Specific Design Plan Dobson Farms Phase 1

SDP-2502

STAFF REPORT

SUBJECT: Specific Design Plan SDP-2502
Type 2 Tree Conservation Plan TCP2-2025-0069
Dobson Farms Phase 1

Figure 1: Specific Design Plan

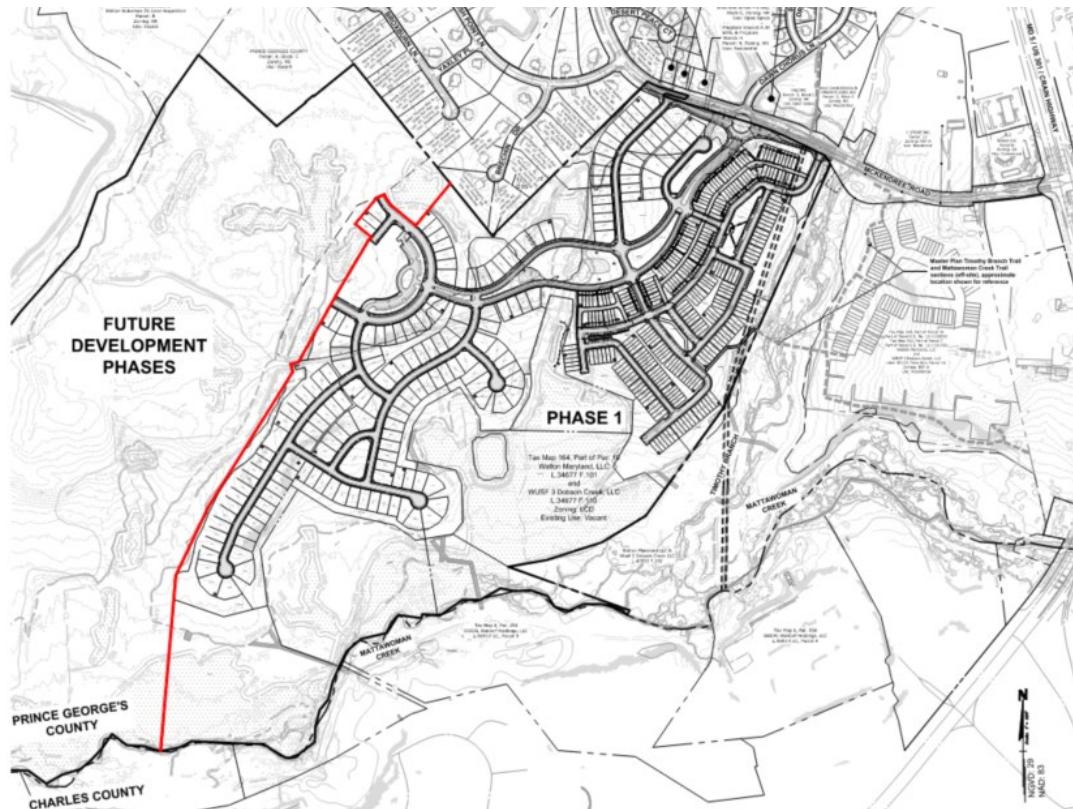
6. **Design Features:** This SDP application is for Phase 1 of the Dobson Farms development, which includes 177 single-family detached and 276 single-family attached residential dwelling units, as well as multiple recreation facilities. The single-family attached (townhouse) units are located at the eastern portion of Phase 1, and the single-family detached units are located at the western portion of Phase 1. The Phase 1 development includes three vehicular access points along the site's frontage of McKendree Road. Within the Phase 1 development, public and private roads form the primary vehicular circulation of the site. While public roads provide access to 177 single-family detached units, private roads and alleys provide access to 276 single-family attached units. The provision of crosswalks, master plan trails, 5-foot-wide sidewalks on both sides of roads, and a 10-foot-wide shared-use path form the pedestrian circulation for the site.

Figure 2: Entrance Sign Elevation (1)

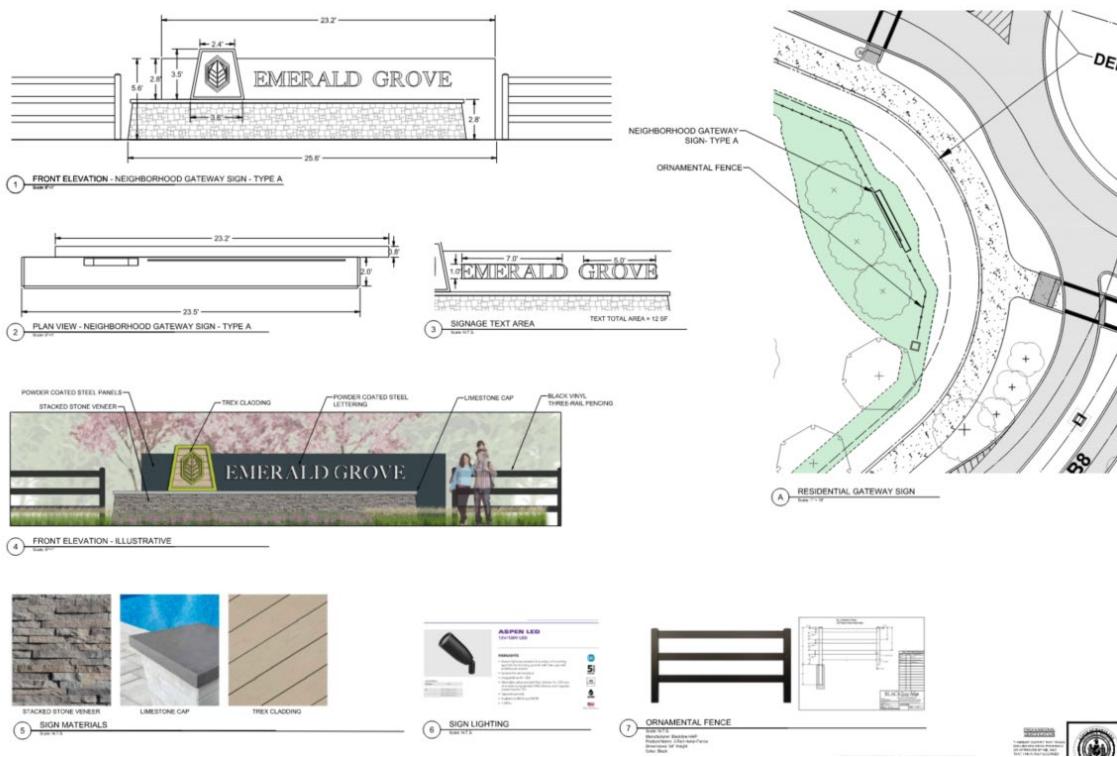
Staff find the sign lettering area is no more than 12 square feet, and the height is less than 6 feet. Signs at the entrance to the residential subdivision are set back from the roadway, which is consistent with the gateway sign regulation per Section 27-624. Staff find that the proposed signs are appropriate in size, type, and design, given the proposed location and the residential uses to be served, and are in keeping with the proposed development in Phase 1.

Figure 3: Entrance Sign Elevation (2)

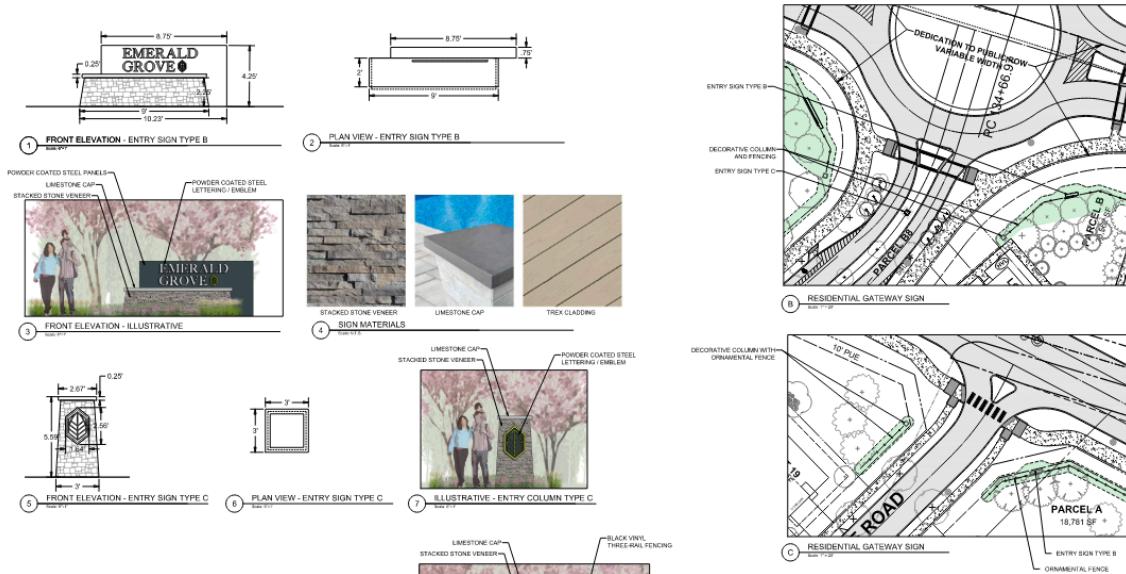
In addition, interpretative signage for Phase 1 is proposed in Parcel A5 for the wetland showcase area. Details are depicted on Sheet 42 of the landscape plan, in accordance with the standards outlined in the *Parks and Recreation Facilities Design Guidelines*. However, the location and amount of the interpretative signage is unclear. A condition is included herein to show the location and number of interpretive signage for the wetland showcase area in Parcel A5.

- e. On Sheet 4, relocate the proposed trees adjacent to Lots 28 and 29 out of the proposed sidewalk.
- f. Show the location and number of interpretive signage for the wetland show case area in Parcel A5.
